ADDENDUM NO. 1

DATE: October 23, 2018
FROM: Village of Villa Park Public Works Department
TO: All Planholders
PROJECT: **Jackson Pond Overflow**

JACKSON POND OVERFLOW PROJECT

SUMMARY OF QUANTITIES

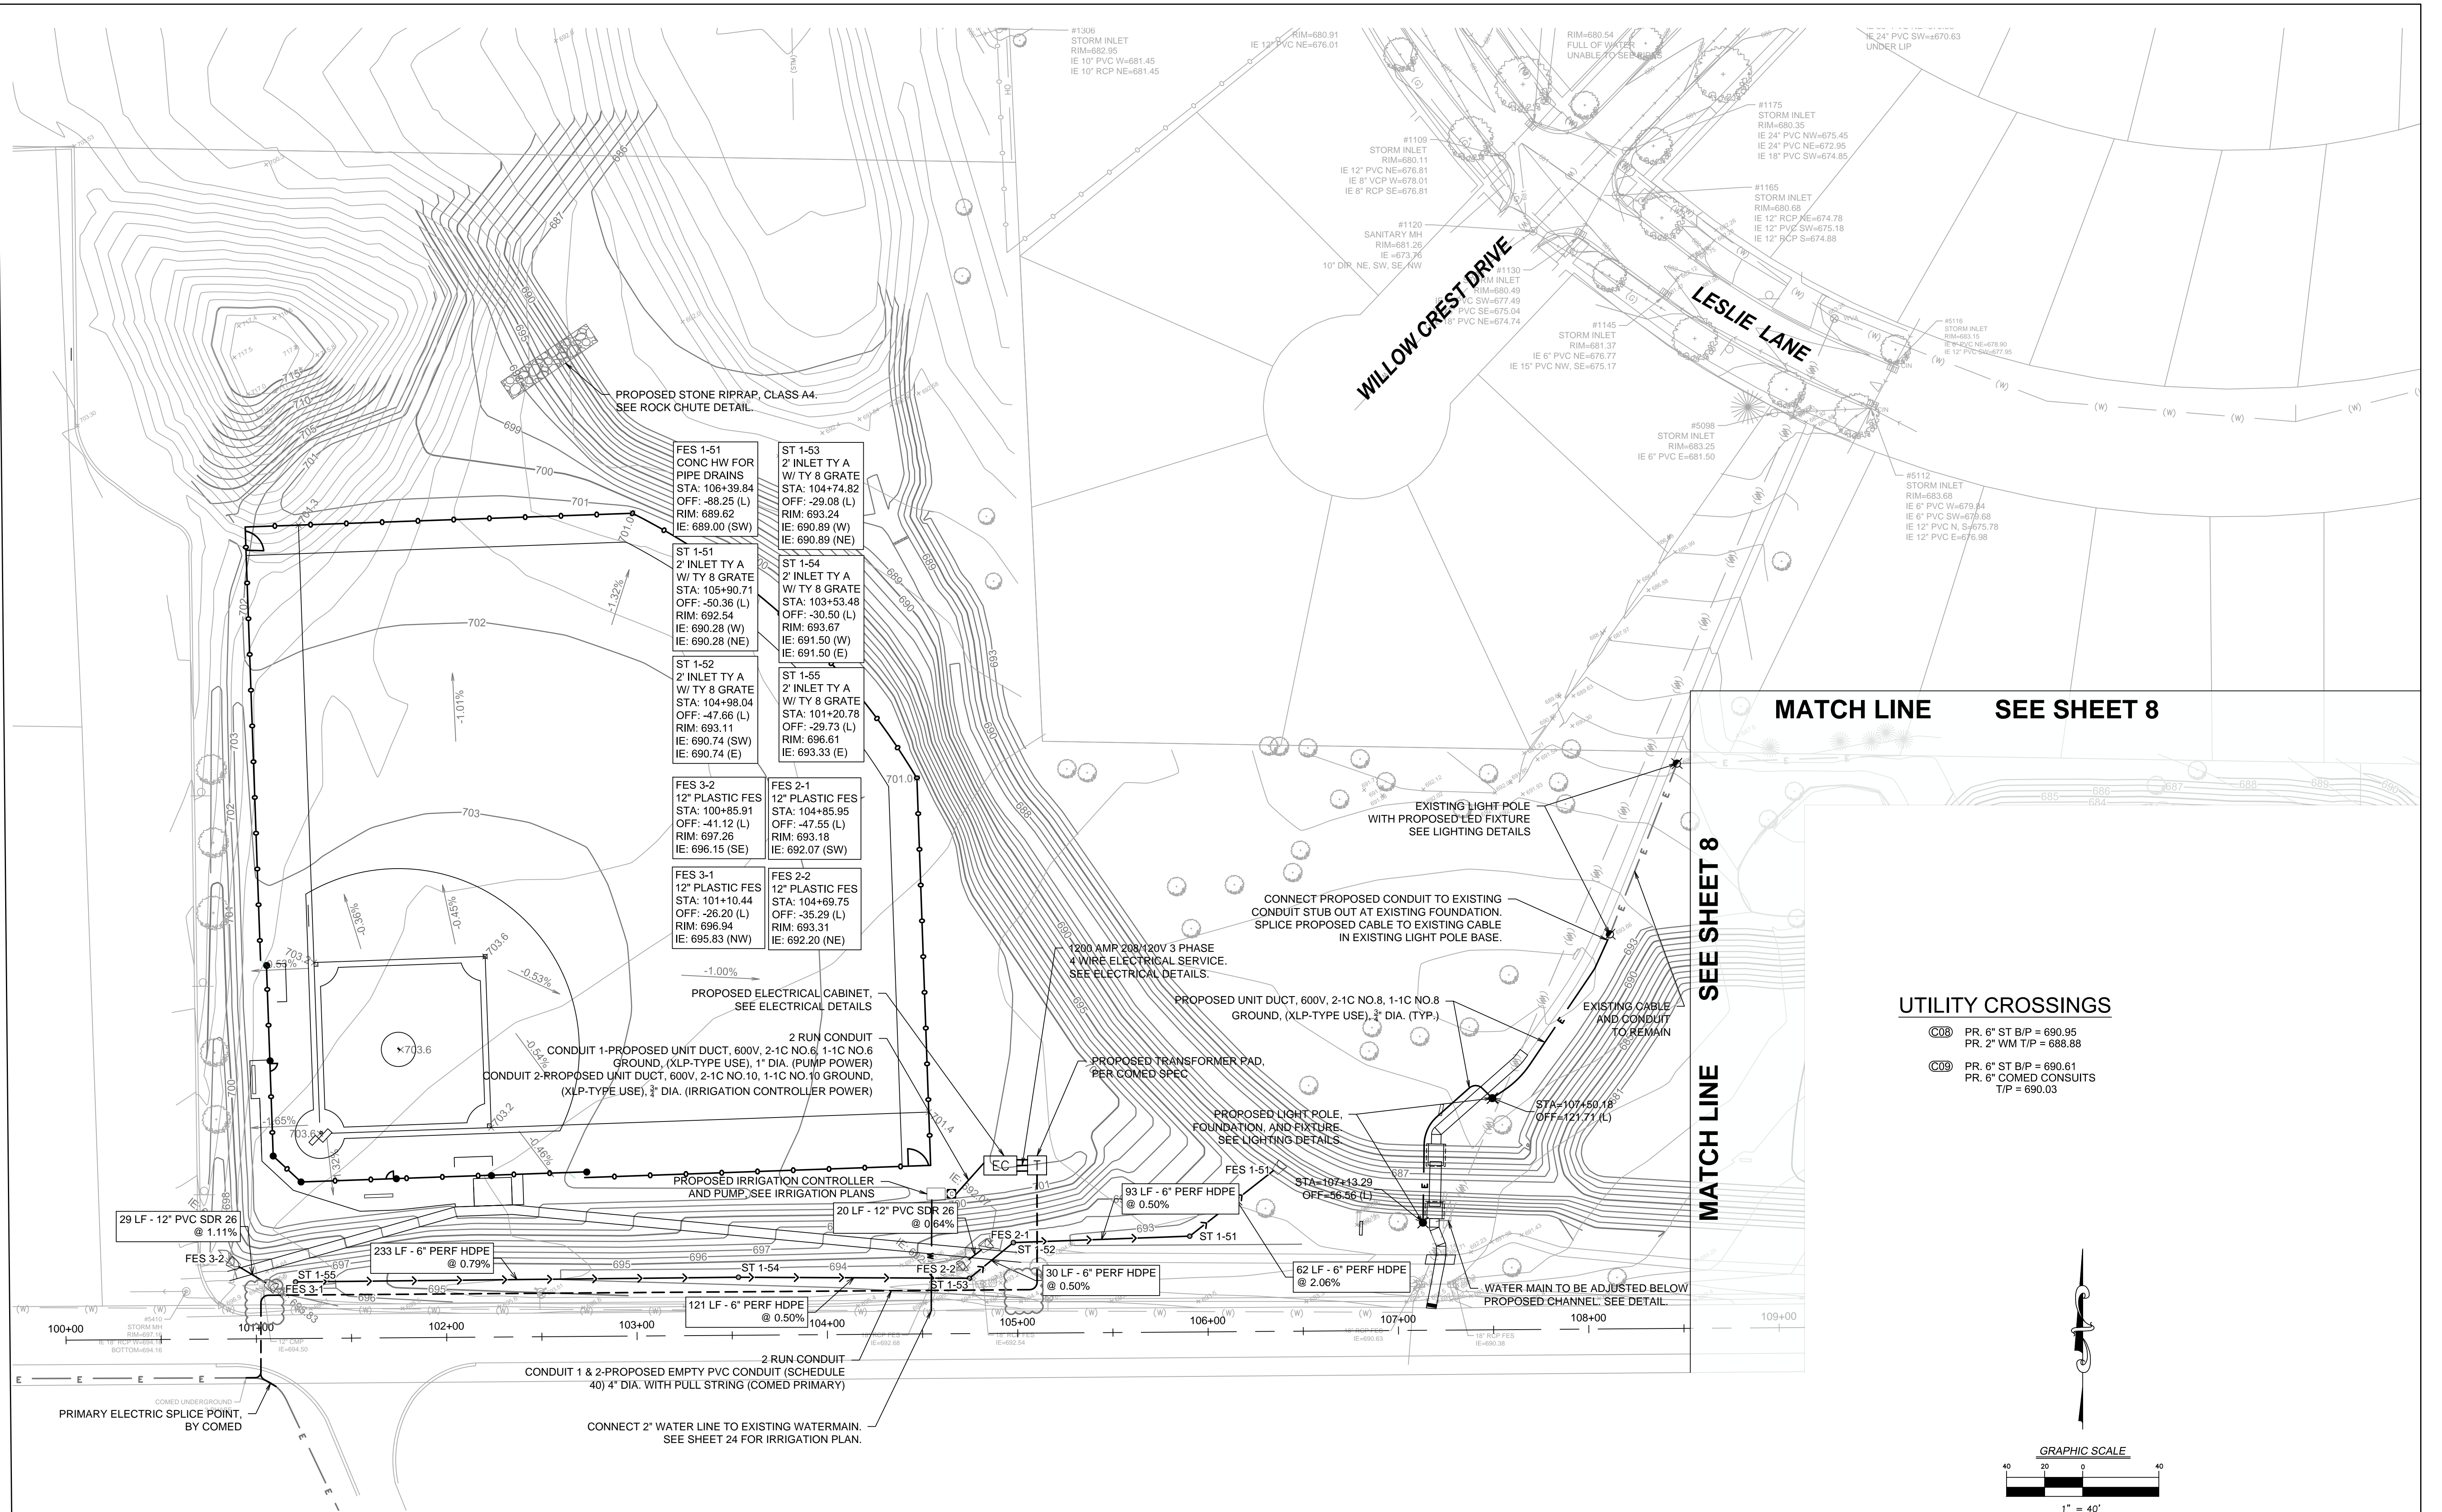
Replace Page 2 of the Plans with the attachment included in this addendum. The revision was made to the quantity for pay item number 88 and pay item number 109 was added. The revisions are bubbled on the plan sheet.

*	109		GEOTEXTILE FABRIC BARRIER	SQ YD	18070

UTILITY PLAN — AREA 2

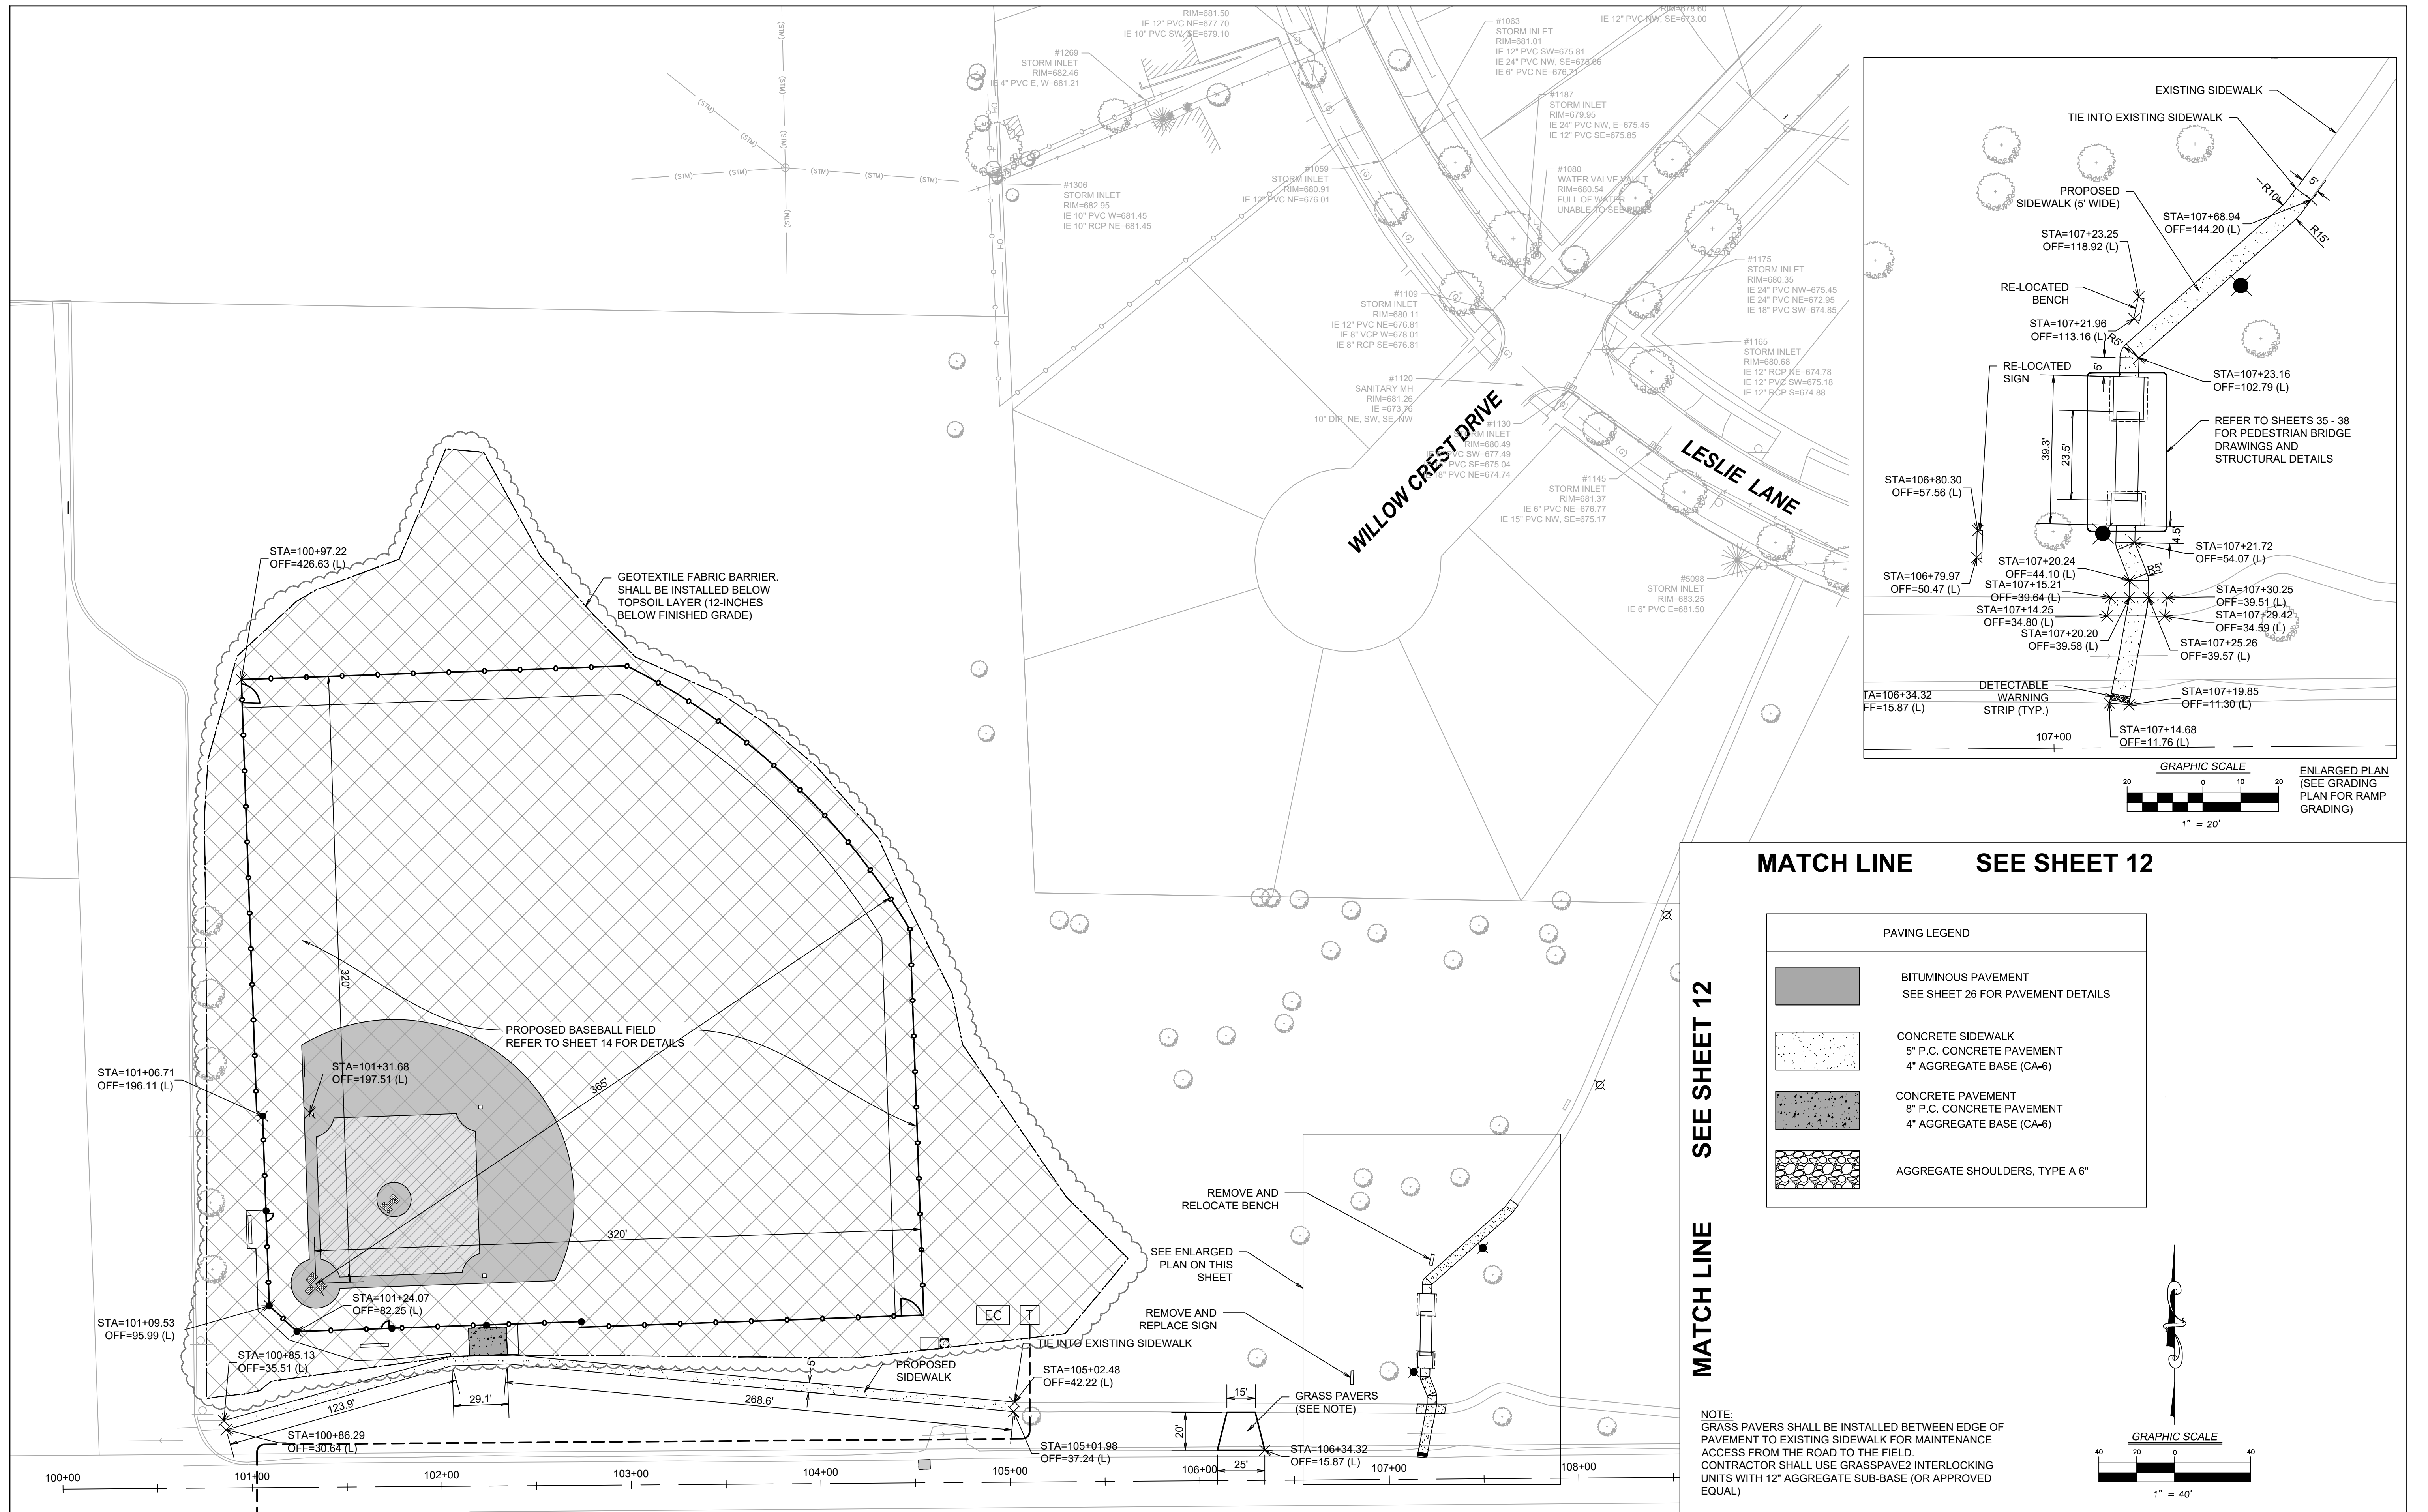
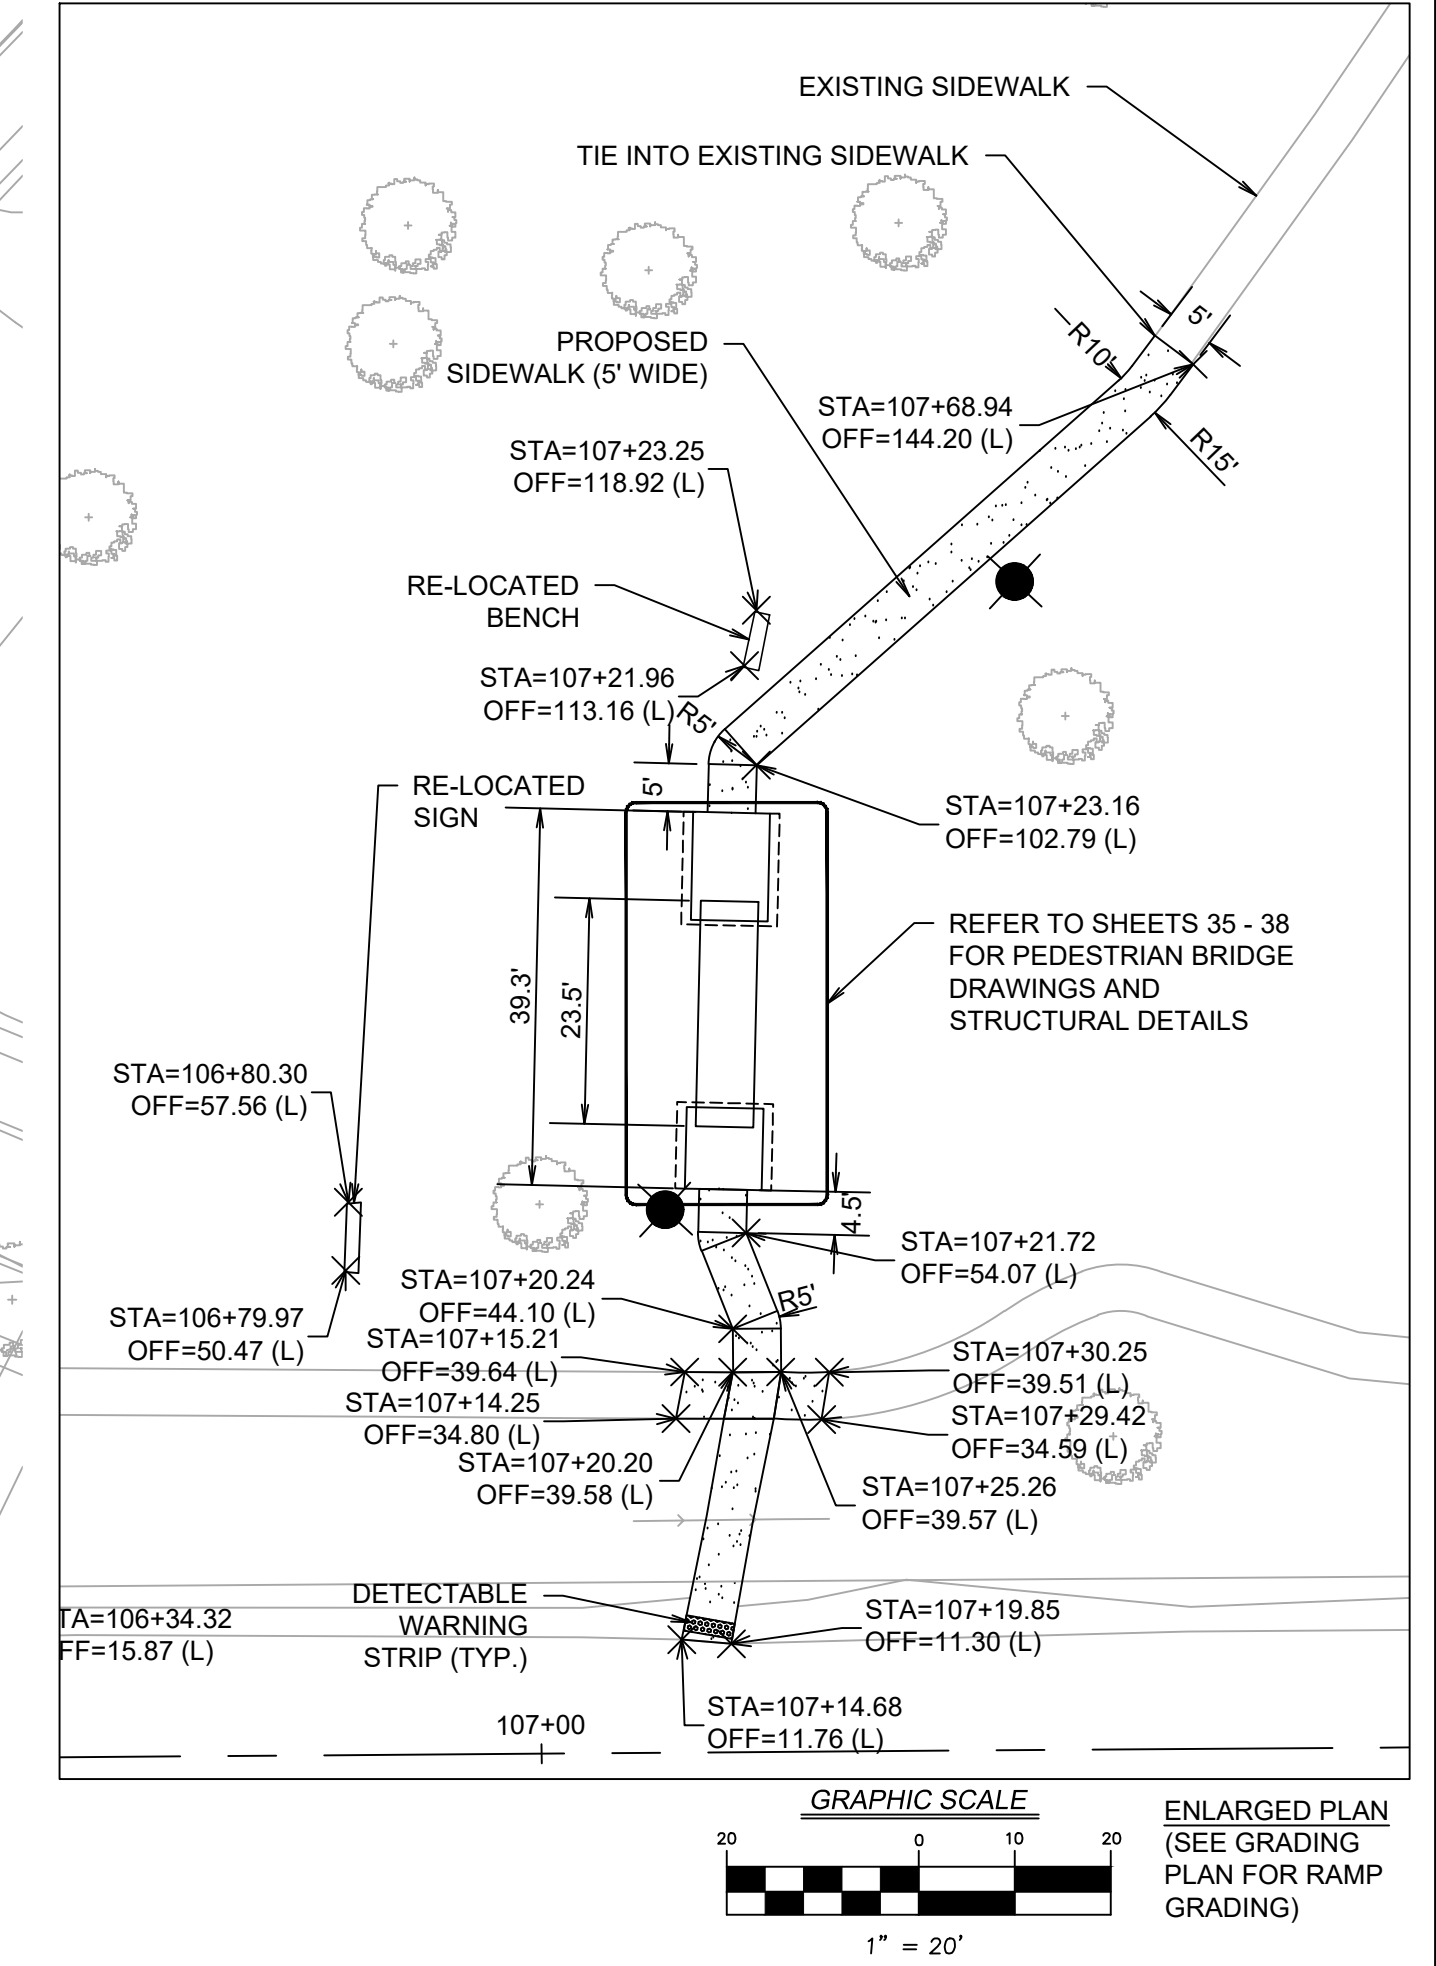
Replace Page 9 of the Plans with the attachment included in this addendum. The revision made was the removal of the ComEd Primary Splice Boxes. The revisions are bubbled on the plan sheet.
